PRE-APPLICATION MEETING MINUTES

1660 Mission Street, Meeting Date April 15, 2026, 2pm (Virtual TEAMS mtg.)

1660 Mission Street (Assessor Blk. 3512/Lot 005)

1660 Mission Street is an existing Type II-A, B-occupancy, six-story building, under 75' in height, over a basement, approximately 103,000 square feet, formerly occupied by DBI and other City functions, currently vacant, and proposed for renovation for Department of Public Health uses. The building includes a basement parking level, Levels 1 through 6, and a rooftop mechanical penthouse.

SIXTH FLOOR
 TITLE:
 A-6
 SHEET:

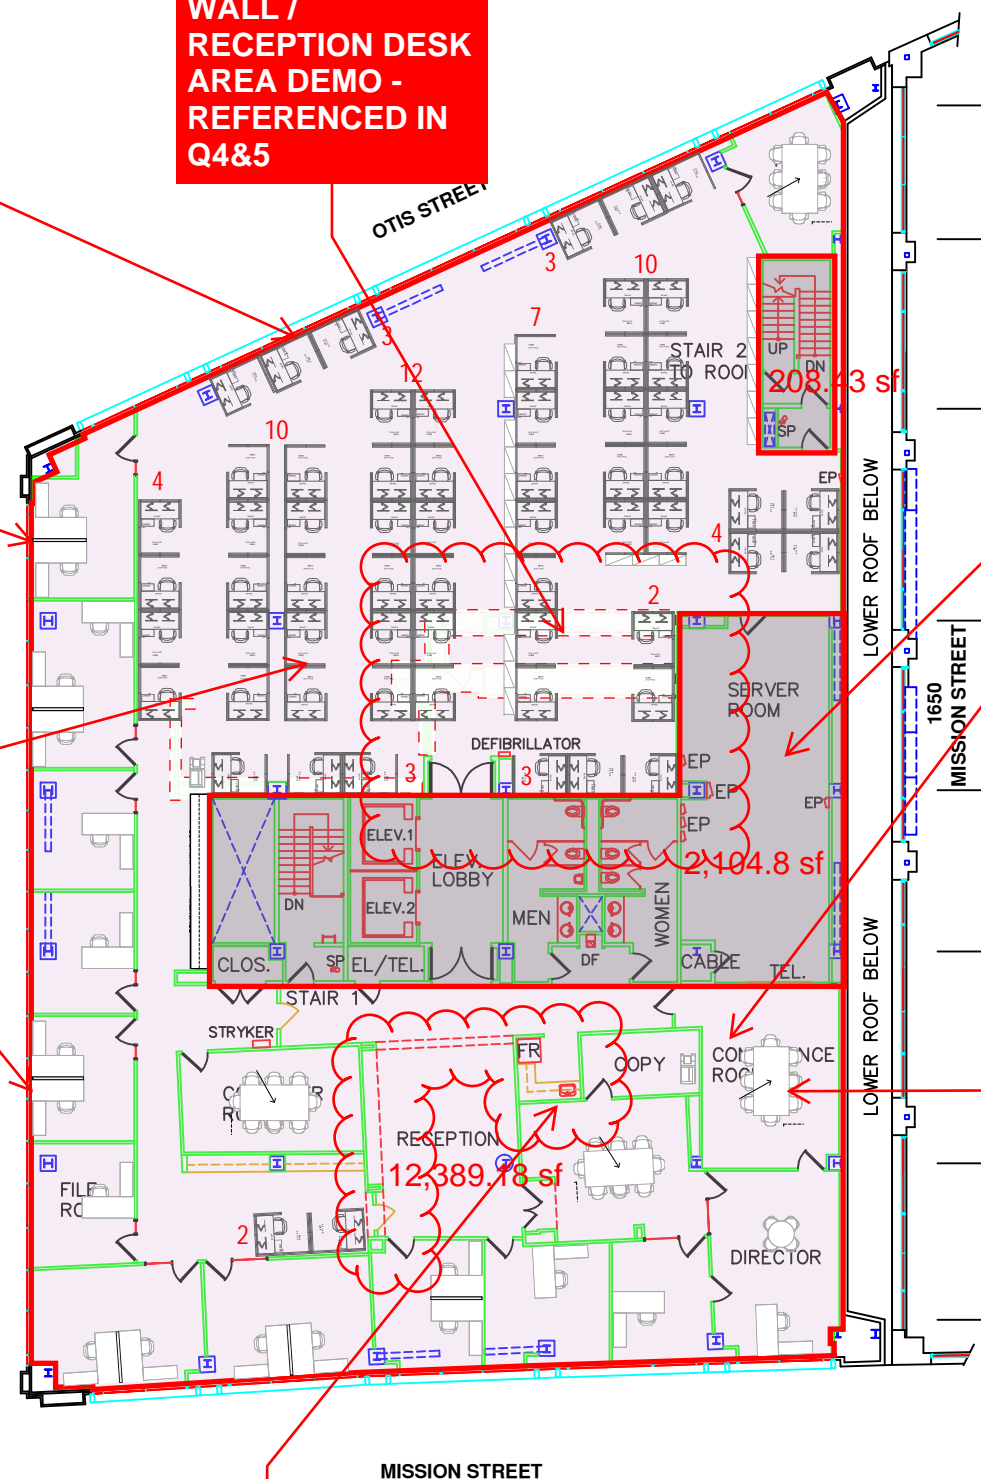
IMPORTANT TO NOTE:
 LEVEL 6 IS A KEY STRATEGY FLOOR FOR MAINTAINING RENOVATION AREA BELOW THE TWO-THIRDS (2/3) THRESHOLD (EXCLUDING BASEMENTS) AND SHOULD REMAIN LARGELY UNMODIFIED.
 THIS FLOOR SHOULD BE PLANNED AS A HIGH-FUNCTIONING ADMINISTRATIVE AND MEETING HUB, SUPPORTING ACOUSTIC PRIVACY AND HYBRID TECHNOLOGY NEEDS.

DAHSED LINE SHOW PROPOSED WALL / RECEPTION DESK AREA DEMO - REFERENCED IN Q4&5

LIMITED COMPLIANCE / TARGETED WORK AREA - REFERENCED IN Q3, Q6, Q7, & Q8

EXISTING KITCHENETTES / CASEWORK IF RELEVANT TO EXEMPT-WORK - QUESTION #4&5

DBI stated that permit-exempt work under SFBC Chapter 1, §106A.2 does not count toward the story-count analysis. DBI cautioned, however, that some items described as “finish work” may still require a permit depending on the actual scope. (SFBC §106A.2; SFBC 304.4 ~~304.5~~)

With respect to counters, casework, built-ins, desks, and similar non-structural millwork, DBI stated that those items may count toward valuation, but are not necessarily treated as wall / partition work unless they are attached to a partition such that the work also alters the partition. If casework or counters are attached to a partition, the partition work would count. If the work is only casework or counters by themselves, DBI indicated that it would generally not be treated as wall / partition work for purposes of the story-count analysis. (SFBC §106A.2(4); SFBC 304.4 ~~304.5~~)

DBI also stated that demolition is considered alteration work. If non-structural partition elements are removed, that removal counts as alteration of those elements. (SFBC §304.4 ~~304.5~~)

ROOF FLOOR

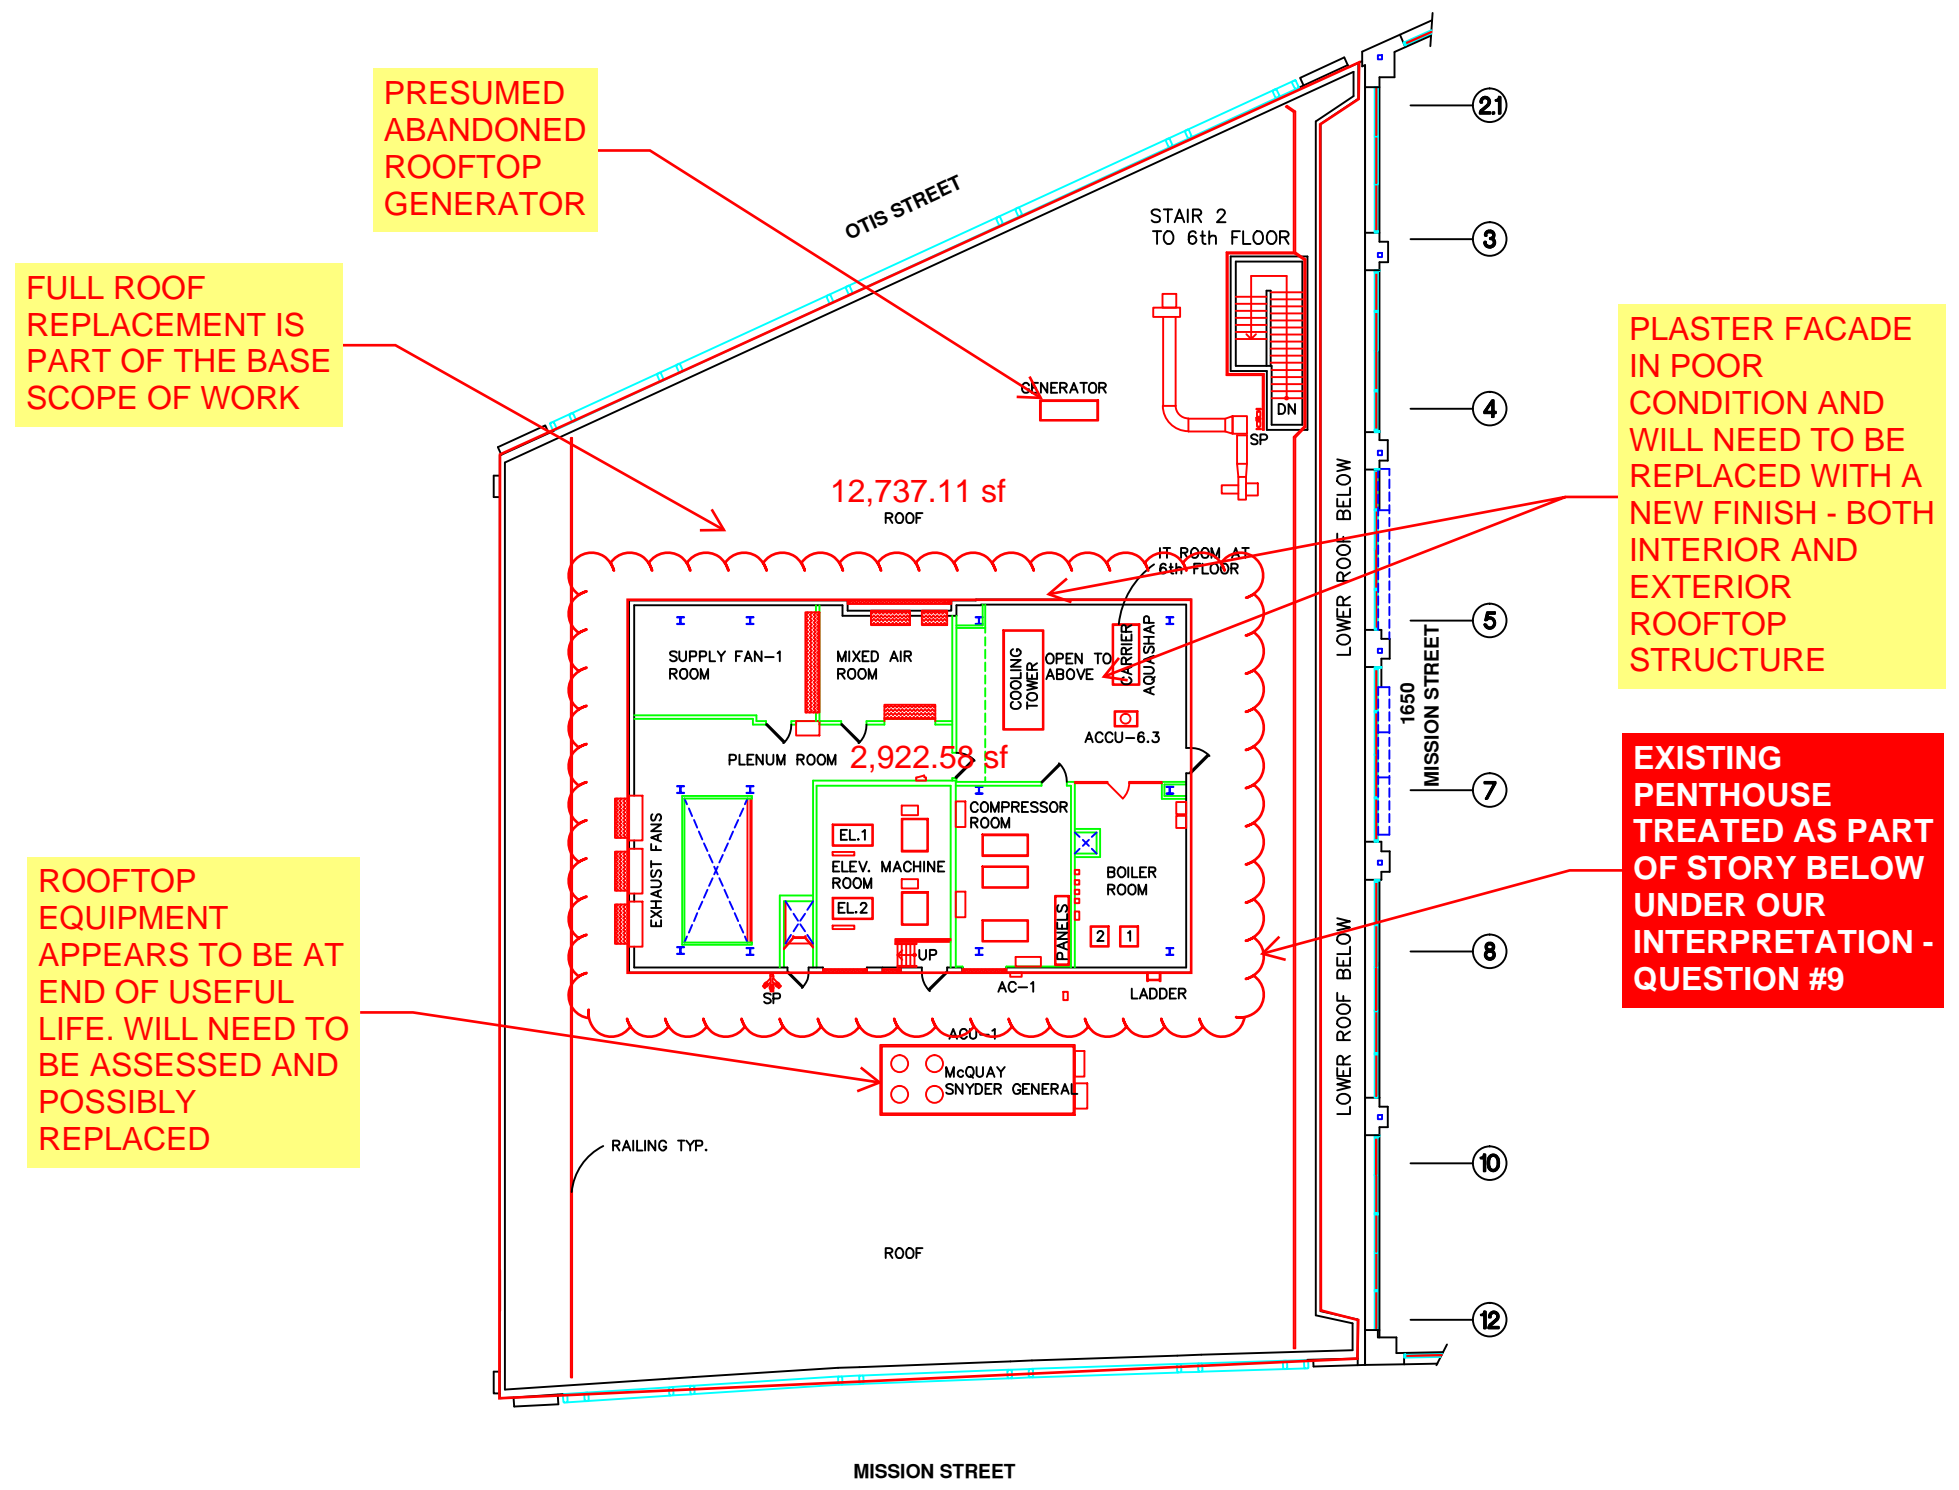
FULL ROOF REPLACEMENT IS PART OF THE BASE SCOPE OF WORK

EXISTING PENTHOUSE TREATED AS PART OF STORY BELOW UNDER OUR INTERPRETATION - QUESTION #9

DBI stated that the rooftop penthouse, as described during the meeting, appears to be a mechanical penthouse and would not be counted as an additional story, provided it is not occupiable space other than for mechanical functions. DBI further stated that, in that case, roof and penthouse work do not count as additional stories for purposes of the story-count analysis. Instead, work on the mechanical penthouse would be considered to occur on the story directly below per CBC 1511.2. (~~CBC §§1511.2, 202~~; ~~SFBC 304.4 304.5~~)

DBI added that roof / penthouse work may still trigger localized structural review if new equipment loads, redistributed loads, or structural changes cause affected elements to exceed the applicable gravity / lateral thresholds at the element level. (~~SFBC §503.11~~; ~~SFBC §§304.3.2, 304.4.3~~; ~~CEBC §805.3 503.3 & 503.4~~)
